Safety Recall Code: 20DR

Subject	Fuel Pump					
Release Date	January 11,	2023				
REVISION SUMMARY	Updated to	Jpdated torque specification for 48V system ground nut				
Affected Vehicles	Country	Beginning Model Year	Ending Model Year	Vehicle	Vehicle Count	
	USA	2020	2021	Q7	19,031	
	USA	2019	2021	Q8	30,412	
	CAN	2020	2021	Q7	2,356	
	CAN	2019	2021	Q8	3,744	
	action. Elsa is ✓ Cam ✓ If Els	the <u>only</u> valid ca paign status mu sa shows other c	ampaign inquiry st show "open. open action(s), i	he day of repair to verify that a VIN qua / & verification source. " inform your customer so that the work of vorkshop for this campaign.	·	
Problem Description	A component of the fuel delivery module inside the fuel tank may break while operating the vehicle. The fragments can damage the sealing membrane in the pressure regulator. This may lead to a failure of the fuel delivery module and the instrument cluster will display the Malfunction Indicator Light (MIL). In rare cases and under certain circumstances, however, there may be a sudden loss of engine power or the vehicle may break down without a warning appearing beforehand. A fuel leak due to this failure can be ruled out.

Subject: Safe

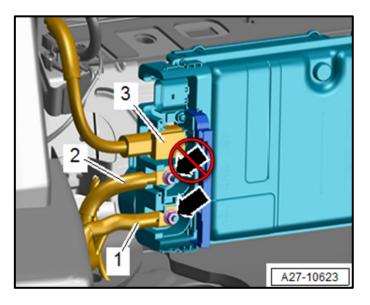
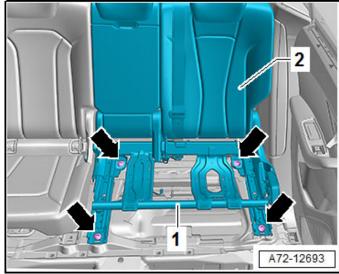
- Torque ground connection <circle> to 3.5 Nm + 45°.
- DO NOT over torque.
